## Addendum 03

<b>Project:</b>	2nd floor addition at 56 Edilcan Drive, Vaughan, for Accord Plastics	<b>Date:</b>	05 April 2024
<b>Project No.</b>	2231	<b>Pages incl. cover:</b>	17

Architect in Charge: Workshop Architecture Inc.	Electrical Addendum	EAD-1 (Addendum #3)
	Issue Date:	April 5, 2024
Project: <b>Accord Vaughan, 56 Edilcan Drive, Concord</b>	Project Number:	2023-1010

MAD-2 (Addendum #3)

**6.0 Drawing E3.1N “Part Ground Floor North Power – New Layout” not re-issued.**

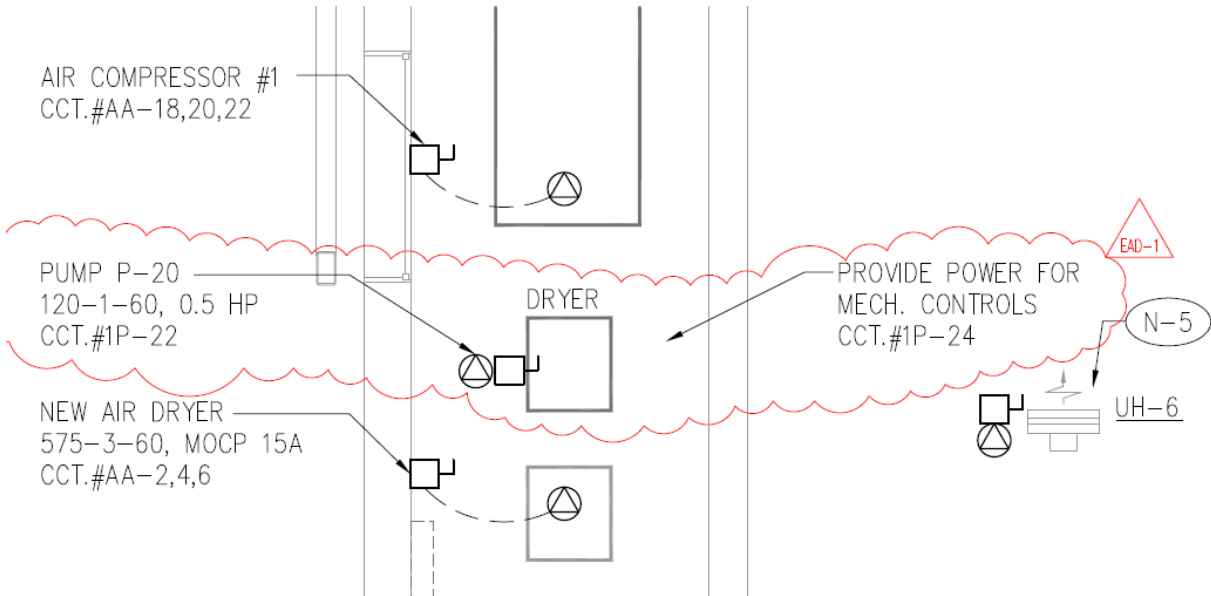
1.5 Add power to pump P-20 and mechanical controls

**7.0 Drawing E3.1S “Part Ground Floor south Power – New Layout” not re-issued.**

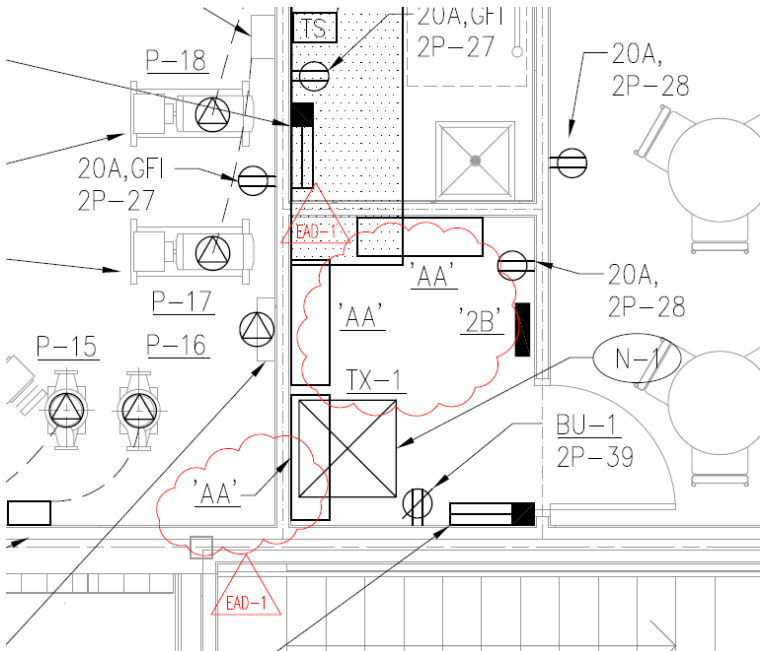
1.6 Panels and transformer tags were added to the drawing

Single Line Diagram  
 Demolition

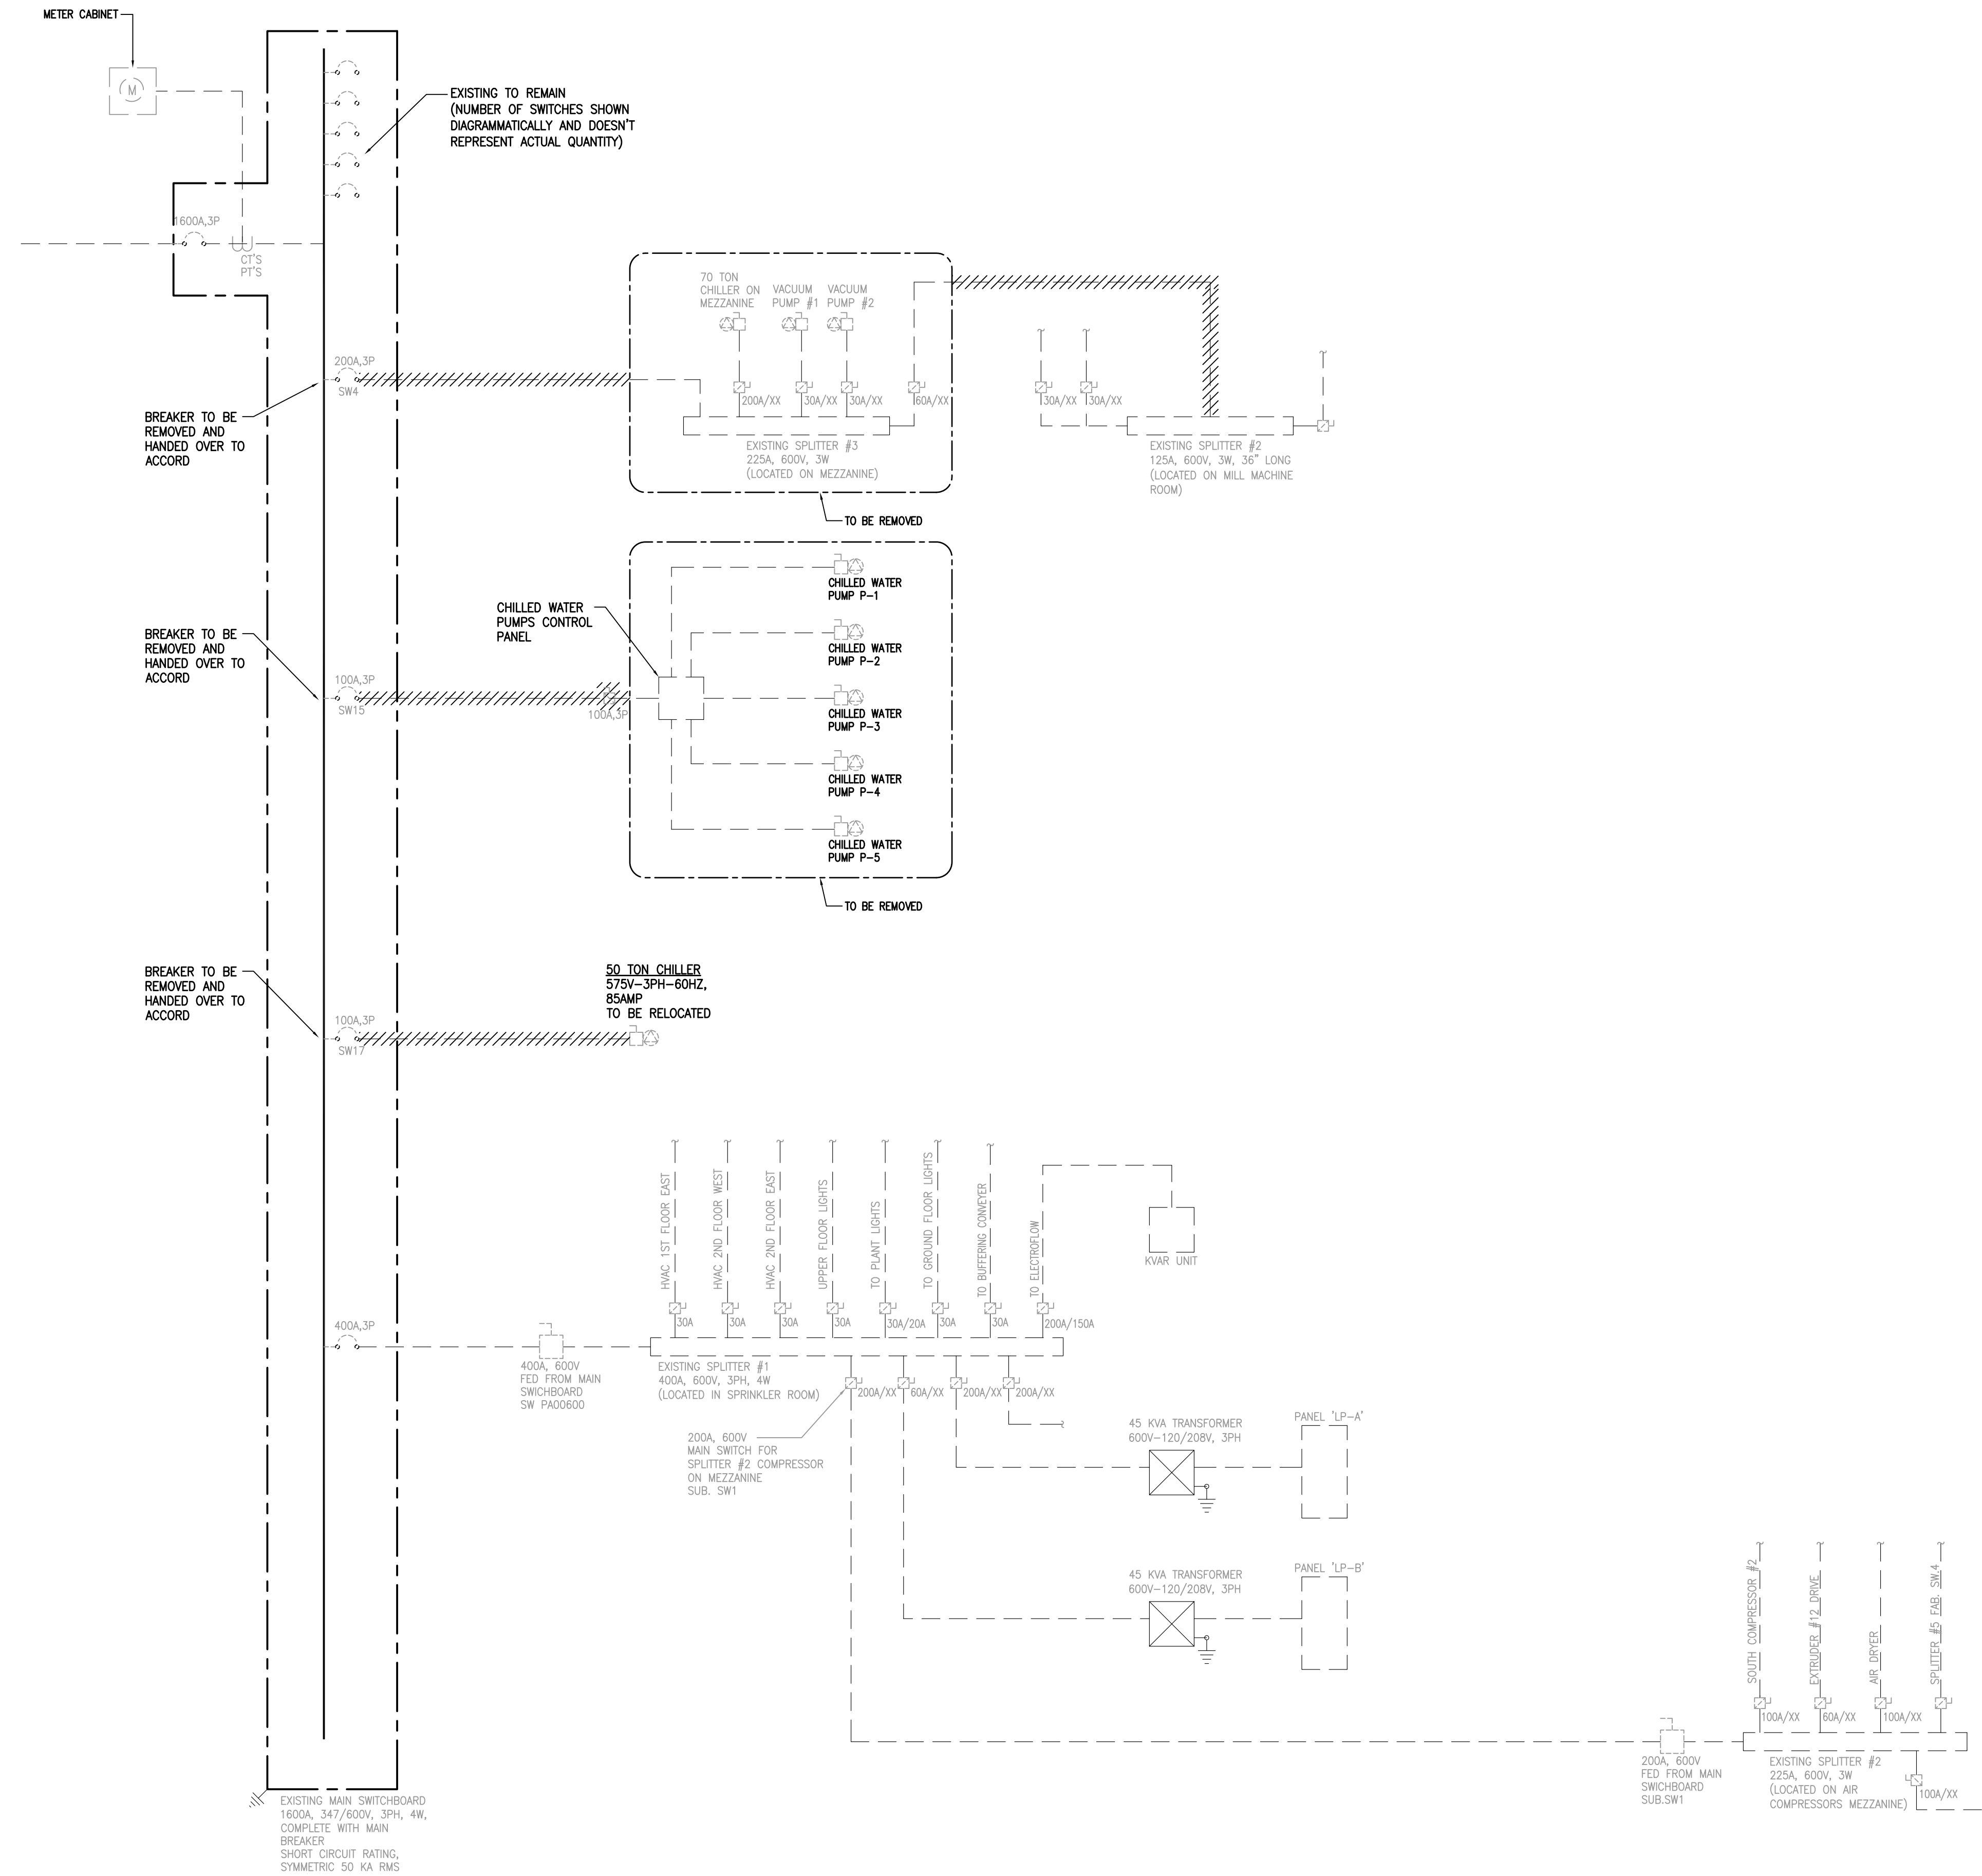
- 1.0 **Drawing E0.2 “Panels Schedule”** re-issued herewith.
  - 1.1 Refer to revisions bubbled in red on the revised drawing
- 2.0 **Drawing E0.3 “Single Line Diagram – Demolition”** re-issued herewith.
  - 1.1 The drawing is revised in its entirety
- 3.0 **Drawing E0.4 “Single Line Diagram – New”** re-issued herewith.
  - 1.2 The drawing is revised in its entirety
- 4.0 **Drawing E1.1S “Single Line Diagram – Demolition”** re-issued herewith.
  - 1.3 Demolition scope is revised – refer to the revised drawing
- 5.0 **Drawing E3.1S “Part Ground Floor south Power – New Layout”** not re-issued.
  - 1.4 Pumps tags were added to the drawing

**1. Drawing M0.2 “Mechanical Equipment Schedules” not re-issued**

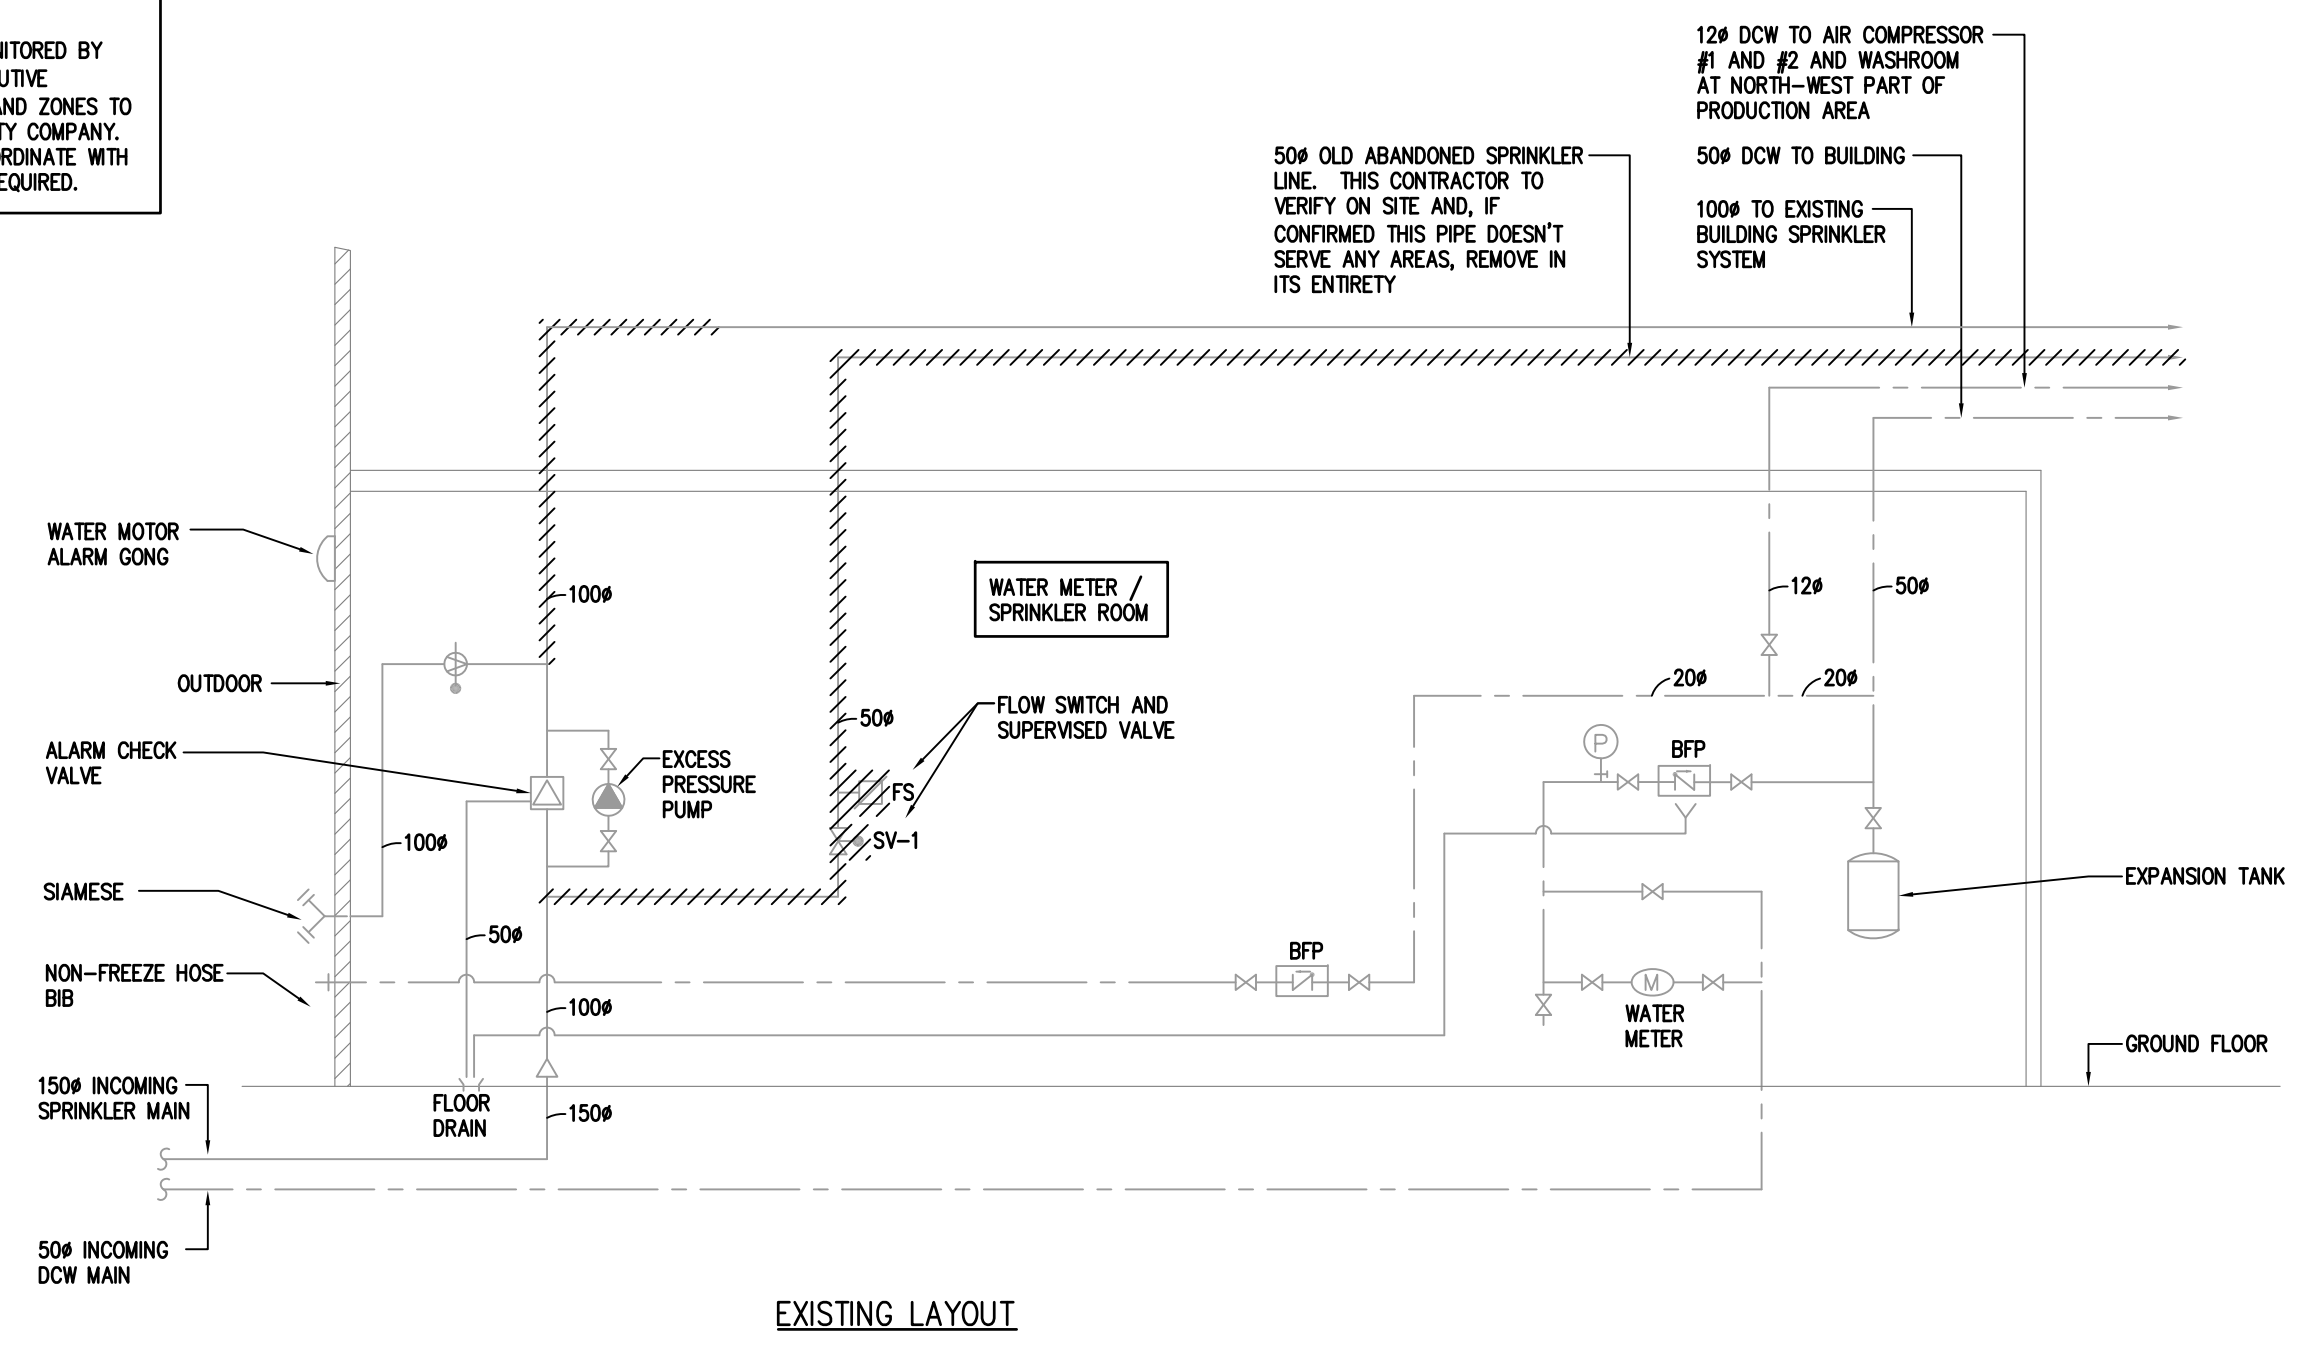
1.1 Pump schedule: pump P-20 is added. Pump to be Armstrong S55 or approved equal, circulator, 120V, 1ph, 60Hz, 0.5HP, 40 gpm, 20ft head, with speed controller at pump for balancing.
